**DEVIATION REQUEST  
 AND DECISION FORM**  
( Judge Orr Deviation )

Project Name : Monument Ridge East  
 Schedule No.(s) : 7102200013, 7102200006, 7102200010  
 Legal Description : TRACT OF LAND IN N2 SEC 02-11-67 DESC AS FOLS, COM AT NE COR OF SD SEC, TH S 89<06'54"  
 W 1320.00 FT, S 00<53'12" W 30.00 FT FOR POB, TH S 89<06'54" W 1834.51 FT TO PT ON ELY R/W LN  
 OF I25, TH ALG SD R/W S 29<33'00" W 180.19 FT, S 89<05'00" W 500.00 FT, S 29<16'30" W 675.30 FT,  
 S 06<43'00" W 36.92 FT, S 89<57'36" E 251.71 FT, S 06<43'00" W 337.98 FT, S 89<57'36" E 732.00 FT,  
 TH N 14<12'38" E 887.45 FT, N 89<06'34" E 500.0 FT M/L, N 00<02'24" W 270.0 FT, S 89<06'54" W 650.0  
 FT M/L TO POB, EX PT DES AS FOLS: TR OF LAND IN NW4 SEC 2-11-67 DES AS FOLS: COM AT NE  
 COR OF SD SEC 2, TH S 89<06'54" W ALG N LN OF SEC 2 A DIST OF 2879.42 FT, TH ON A  
 DEFLECTION ANGLE TO THE L OF 90<00'00" 50.00 FT TO A PT 20.00 FT S OF EXISTING SLY R/W LN  
 OF COUNTY LINE RD FOR POB, TH N 89<06'54" E 105.00 FT, S 13<48'06" W 130.00 FT, S 89<06'54" W

**Deviation No. 1** (Rev. 10-4-2024) A deviation from the standards of or in Sections 2.2.5.D. **2.3.2 and 2.3.7.B. Collector Access Standards** of the Engineeri

Deviation No. 1 - Exhibit 1

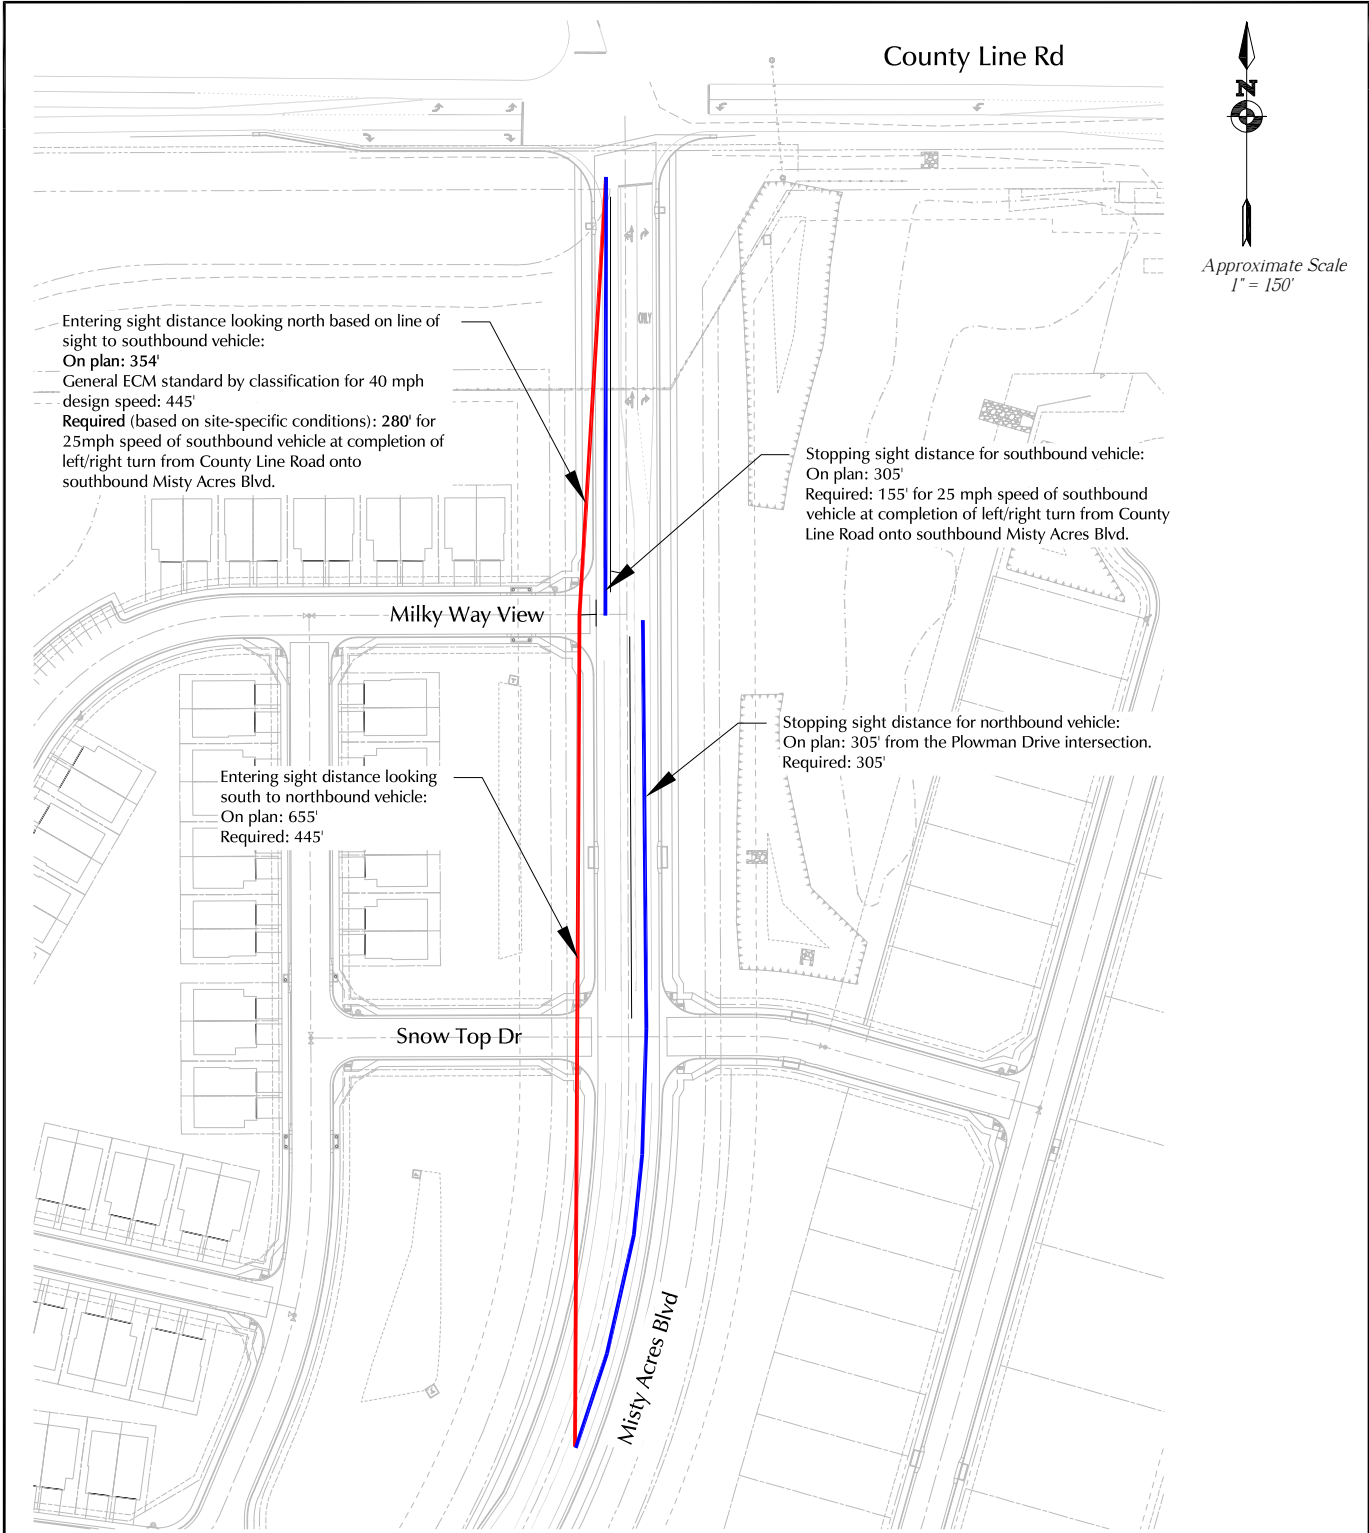
Deviation request is to allow the proposed north access point location: Milky Way View to the planned extension of Misty Acres Boulevard. This deviation involves the intersection spacing of Milky Way View 395 feet to the north to the future County Line Road/Misty Acres Boulevard intersection.

As the adjacent intersection to the north is an Arterial (County Line Road), the standard requires an intersection centerline spacing of 660 feet. Centerline spacing on Misty Acres Boulevard between County Line Road and the Milky Way View would be 395 feet (see Deviation Exhibit 1).

-  Existing roadway
-  Proposed roadway
-  Portion of proposed roadway for which deviation is requested
-  Intersection centerline spacing - 395' proposed, 660' required (Table 2-7)  
(660' to the first street intersection from an arterial intersection)
-  Site property boundary

This request has been determined to have met the criteria for approval. A deviation from Section 2.2.5.D, 2.3.2, 2.3.7.B of the ECM is hereby granted based on the justification provided.
